UNITED STATES PATENT AND TRADEMARK OFFICE

Office Action Summary

10/593,849

OLOVSON, GUDMAR

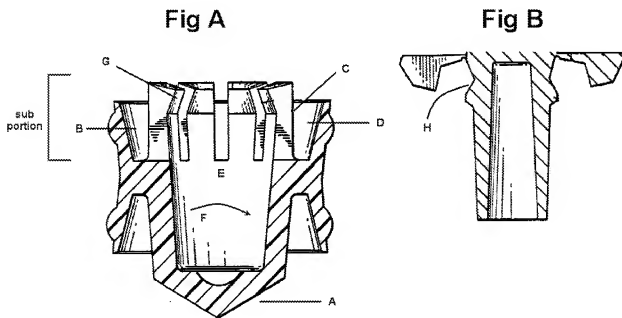
11. Claims 1 and 3, as best understood, are rejected under 35 U.S.C. 102(b) as being anticipated by Hammett (US Pat 5,181,912).
12. Re claim 1, Hammett discloses a syringe 10 (Fig 1) of non-reusable type comprising: a container 11 (Fig 1), a rod 16 (Fig 1) cooperating with said container, a piston unit 30 (Fig 1) inserted in and reciprocally disposed in said container, and a needle 14 (Fig 1); the rod being, by the intermediary of an axial displacement movement, reciprocally disposed in said container and displaying in its end portion, enclosed by the container, a first coupling device 23 (Fig 3) within a two-part coupling

arrangement (Fig 3), whose second coupling device 47 (Fig 7) is related to said piston unit; and where said two coupling devices assume a mutual cooperation and an active position while the piston unit is, by the movement of the rod, displaced from a position, closely adjacent said needle, to a position distal from said needle and gradually brings said coupling devices towards and into an inactive position, while the piston unit is, by the movement of said rod, displaced from the position distal from the needle towards and/or to the position closely adjacent said needle, the two coupling devices permitting, in an inactive position, an axial movement of the rod to take place without cooperating with said piston unit (Col 2, Lines 25-36); wherein, said second coupling device is provided with a piston unit related means 34 (Fig 7), rotary coordinated with a piston A (best seen in Fig A below) within a piston unit; said unit displays a sub portion (best seen in Fig A below) adapted for a rotary cooperation with a recess B (best seen in Fig A below) in said piston unit; said means displays a supporting sliding surface C (best seen in Fig A below), facing towards a sliding surface D (best seen in Fig A below) provided on said piston unit where in any event one of said sliding surface is of a planar configuration; said means also displays a portion facing inwardly into the container with a sliding surface E (best seen in Fig A below) associated with the coupling device and given a configuration and a curvature F (best seen in Fig A below) associating to a cylindrical helix and/or to a conical helix, whereby said portion of the means facing inwardly into the container, displays a support surface G (best seen in Fig A below), oriented transversely of a centre line related to said means, and that said support surface is cooperating with a further support surface H (best seen in Fig B below), each
